FINAL DRAINAGE REPORT

LOT 1 & LOT 2 CROSSROADS MIXED USE FILING NO. 2 EL PASO COUNTY, COLORADO

FEBRUARY 2023

Project #18-005
PCD Filing No.: SF XX-XXX

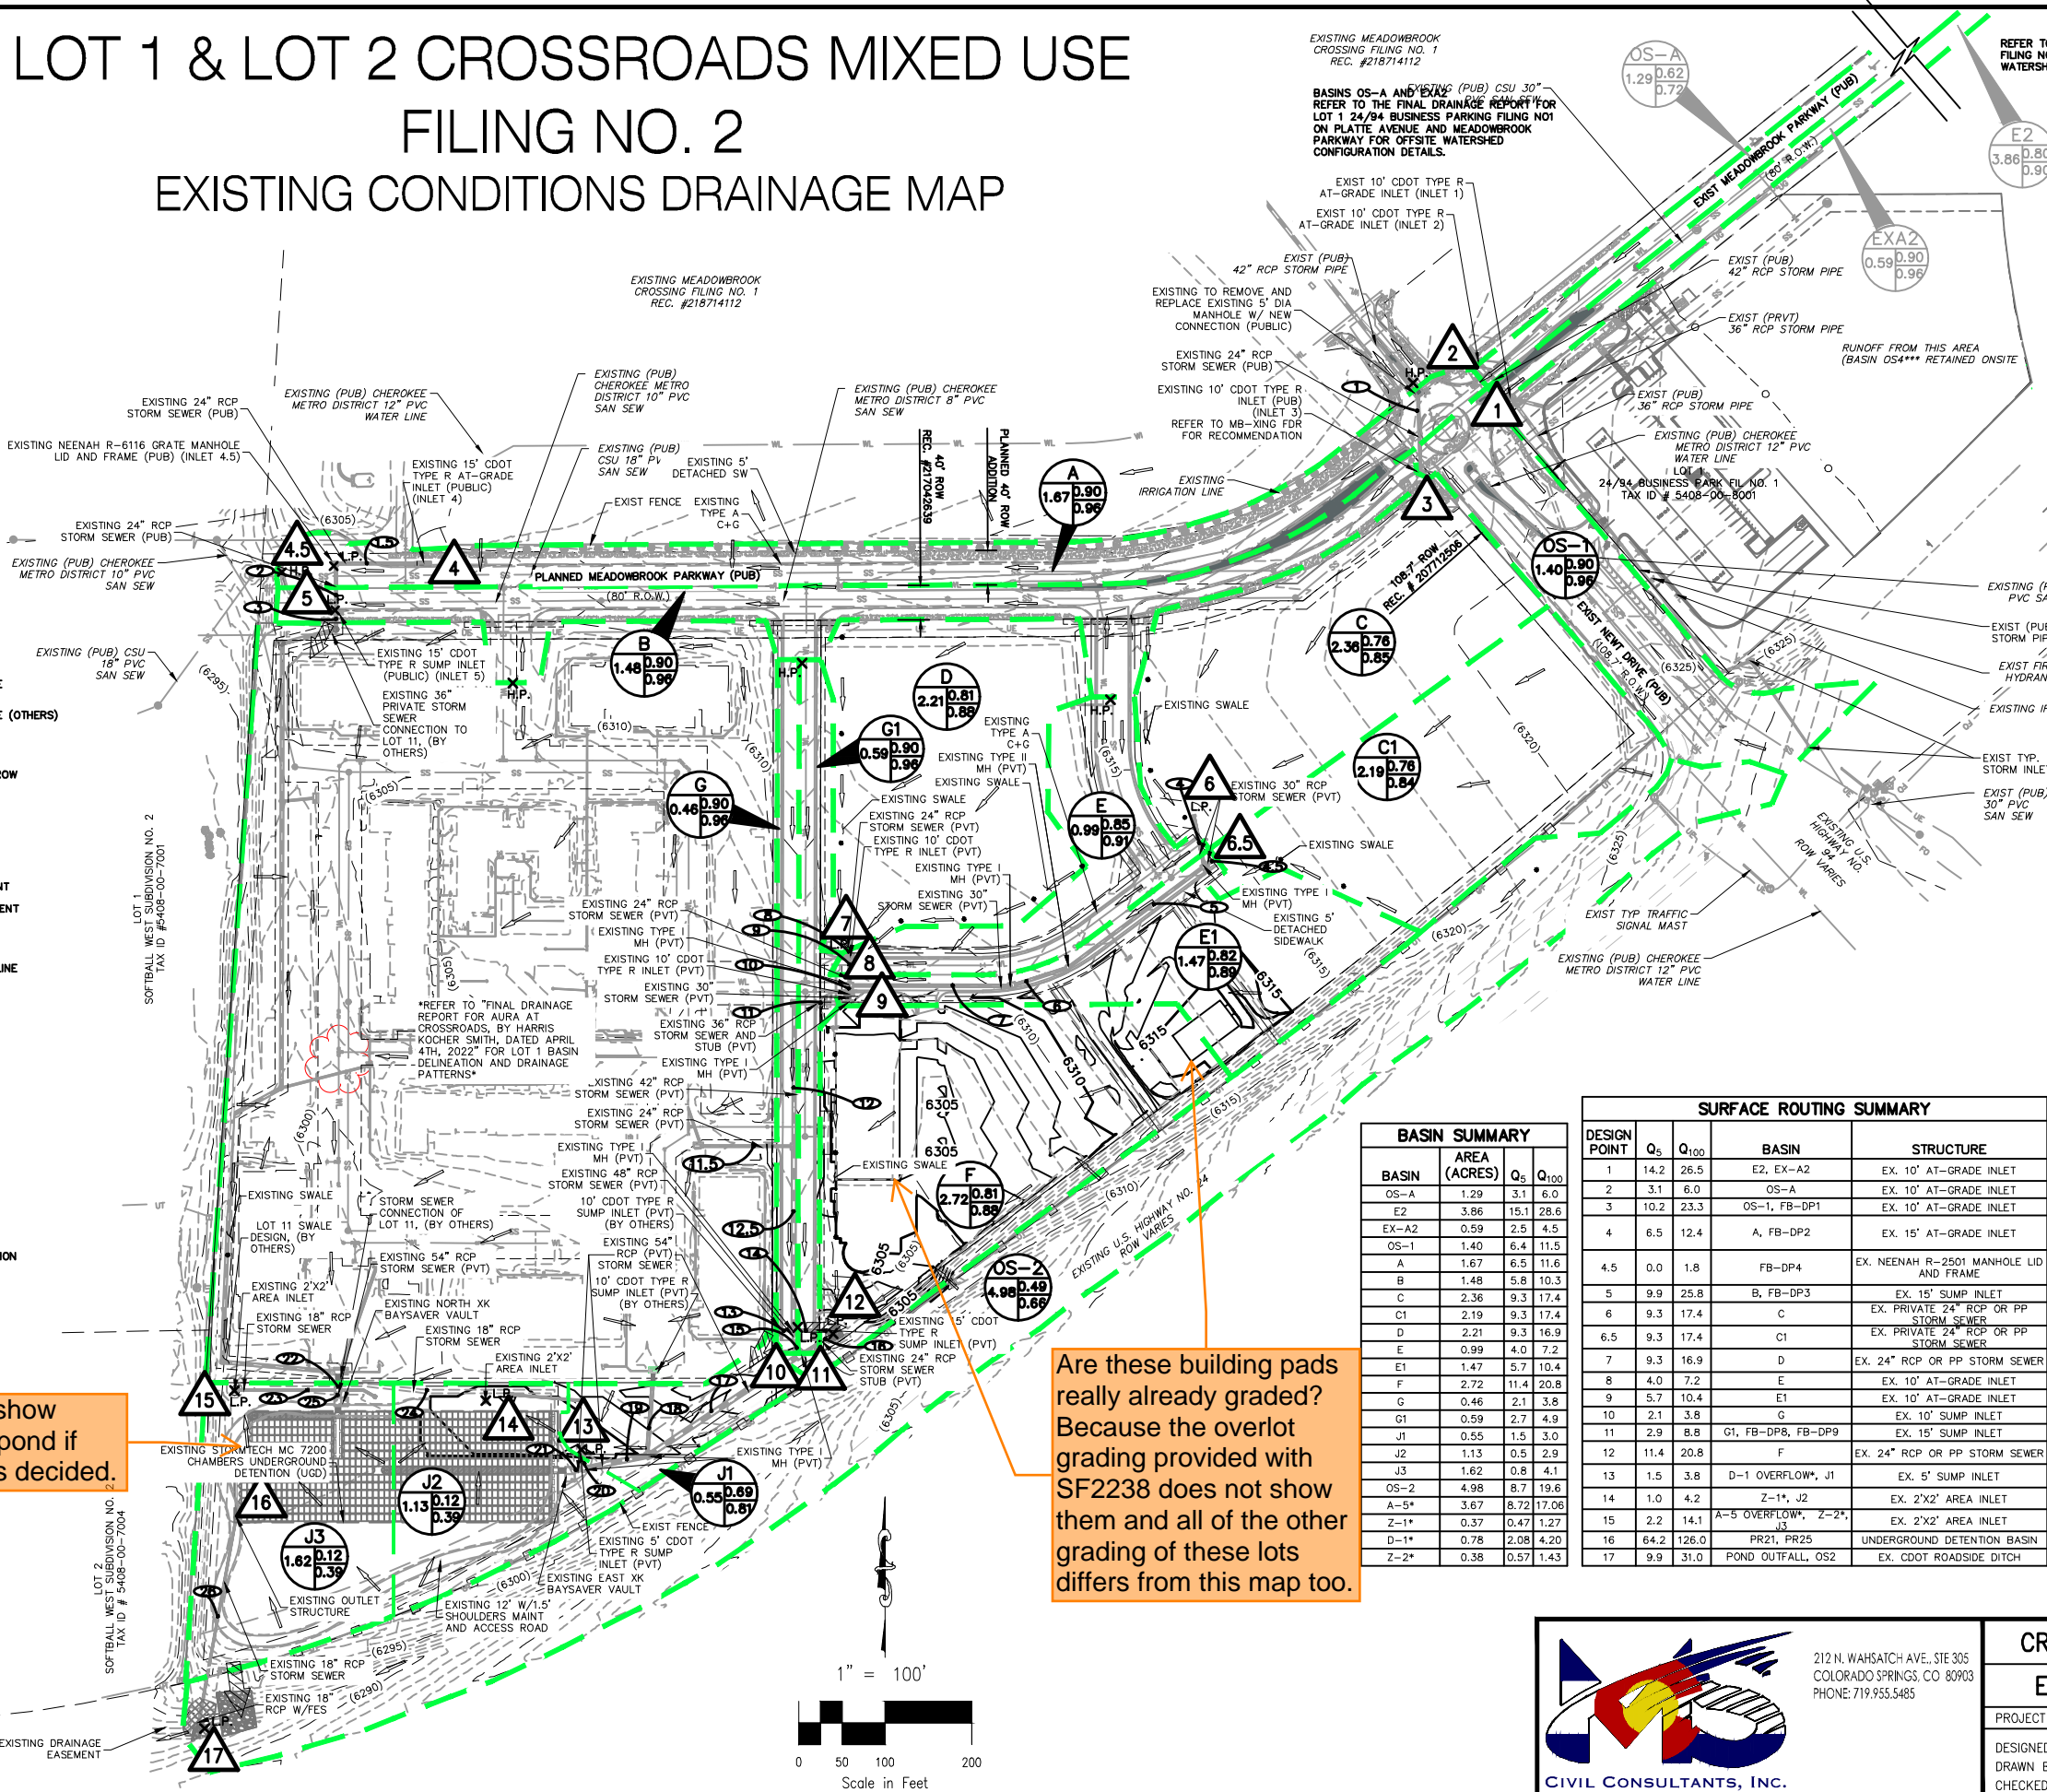
revise map to show above ground pond if that's what was decided.

Are these building pads really already graded? Because the overlot grading provided with SF2238 does not show them and all of the other grading of these lots differs from this map too.

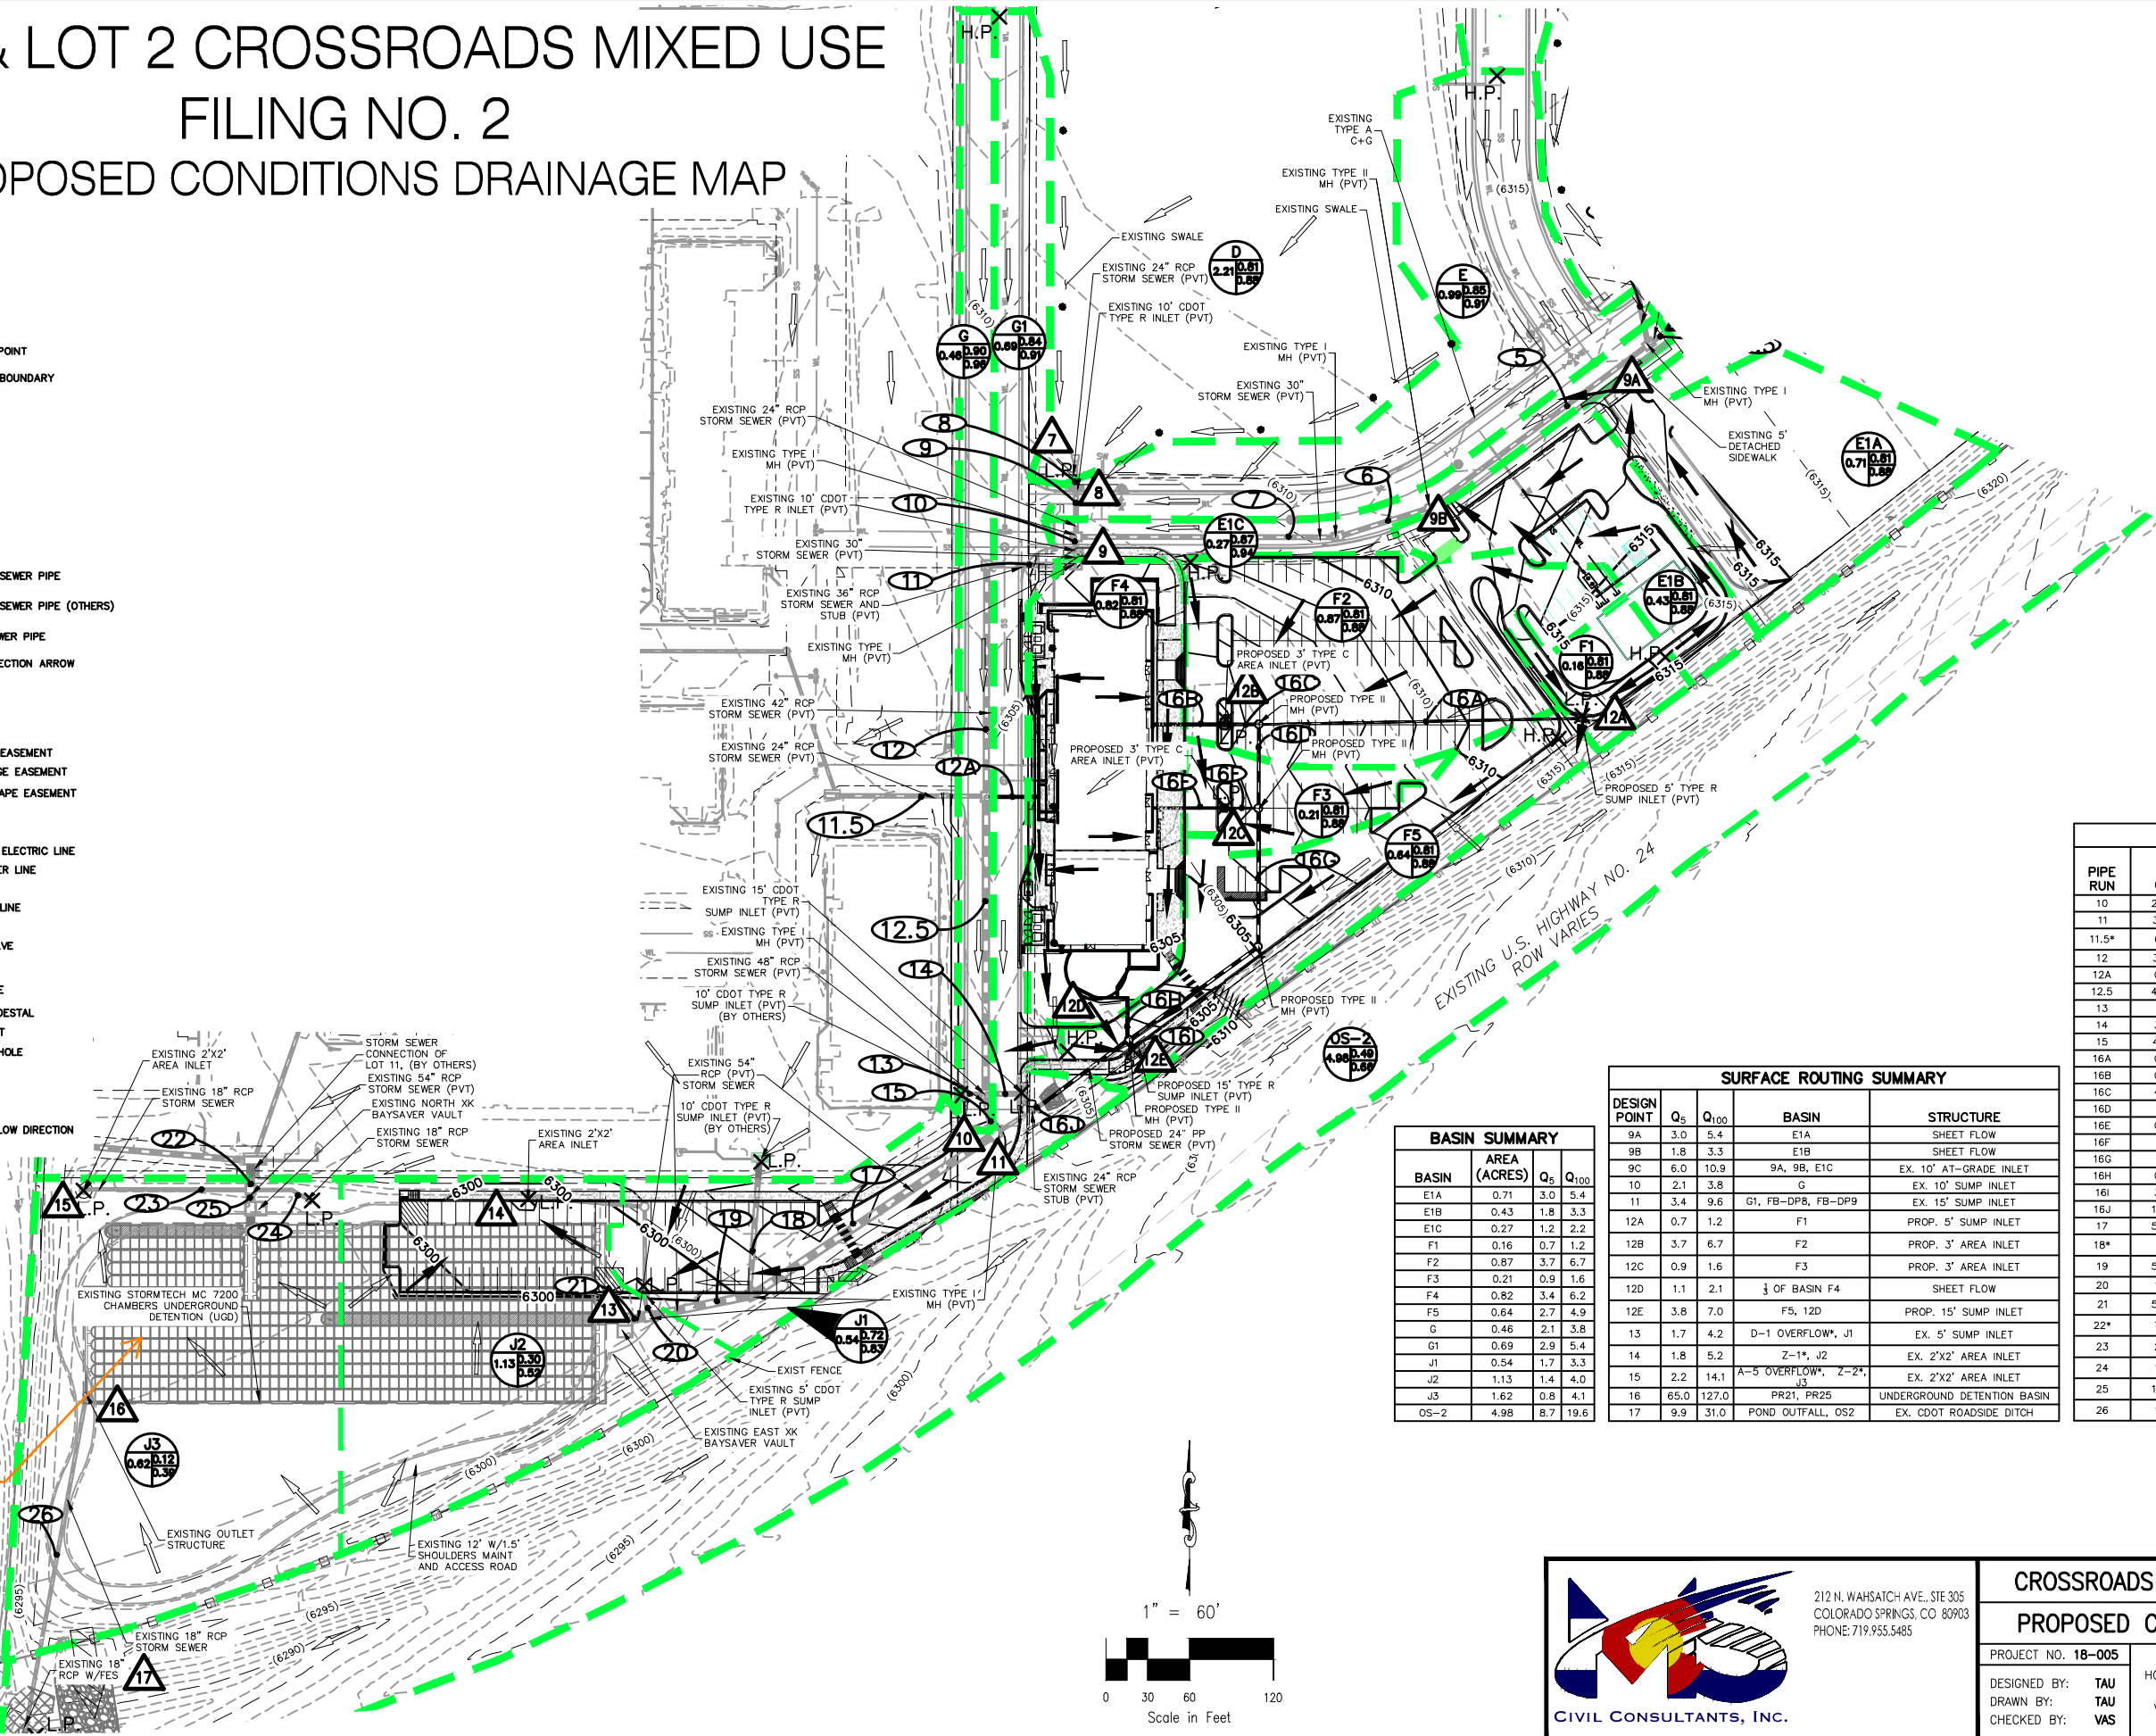
revise map to show above ground pond if that was what was decided.
